**BIDDING FOR THE CONSTRUCTION OF ROADS, UTILITIES AND PREPARATORY
WORKS AT MORONG DISCOVERY PARK**

BID BULLETIN NO. 6

This Bid Bulletin contains clarifications for various queries from prospective bidders, and other matters relating to the Project and shall form an integral part of the Bidding Documents.

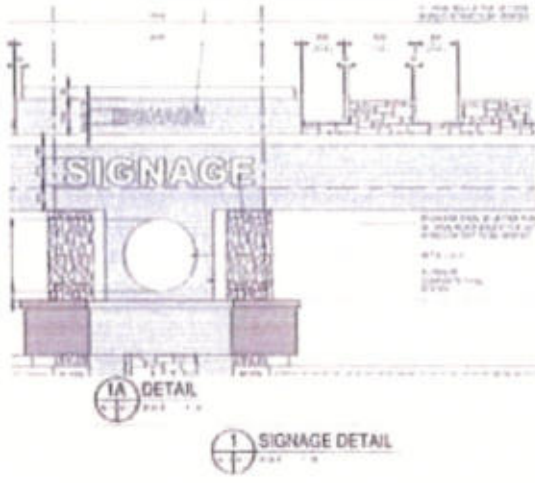
<p>Q24. General.</p> <p>Please confirm if the Application for Permanent Power Connection to the Electric Cooperative is not included in the Scope of Works of the Contractor.</p>	<p>The application for permanent power connection to the Electric Cooperative is included in the Scope of Works of the Contractor.</p>
<p>Q25. Site Development BOQ - Exterior Power Distribution System.</p> <p>Please confirm if the scope of works for the Item "OVERHEAD POWER DISTRIBUTION SYSTEM" is from First Private Pole going to the Distribution line inside the Site Boundaries only.</p>	<p>Yes. The overhead power distribution system is only from the First Private Pole going to the distribution line inside the project site.</p>
<p>Q26. General.</p> <p>Please provide a detailed Layout Plan for the Lighting System for the</p>	<p>Please refer to Electrical Drawing Sheet Nos. E8-2, E9-2, E10-2, E29.9-2, E30-</p>

Buildings.	3, and E50-3.
Q27. General. Please provide sample photos for the different types of Lighting Fixtures.	Please refer to the lighting fixture schedule and electrical legend in the drawings.
Q28. Bill of Quantities On the BOQ provided, please confirm if the scope of works for the Fire Alarm system is Roughing ins only.	Yes, the scope of works for Fire Alarm System includes roughing-ins only.
Q29. Bill of Quantities On the BOQ provided, please confirm if the scope of works for the Network Cabling System is Roughing ins only.	Yes, scope of works for Network Cabling System includes roughing-ins only.
Q30. Bill of Quantities On the BOQ provided, please confirm if the scope of works for the CCTV System is Roughing ins only.	Yes, scope of works for CCTV system includes roughing-ins only.
Q31. Site Development BOQ Item no. 1109 "Grounding System". Please provide a detailed layout plan for the Grounding System.	Please refer to the Standard Footing Detail in Electrical Drawing Sheet No. E0-5 for details.

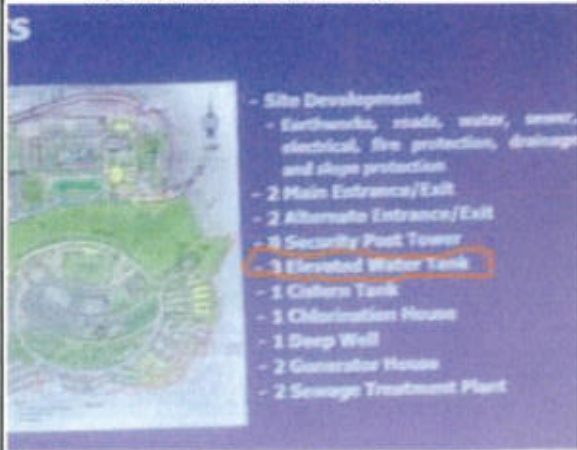
Q74. Electrical Works - Network Cabling System (Roughing-ins only).
1. The missing items are as follows, and the quality needs to be confirmed.

Scope of works for Network Cabling System includes roughing-ins only.
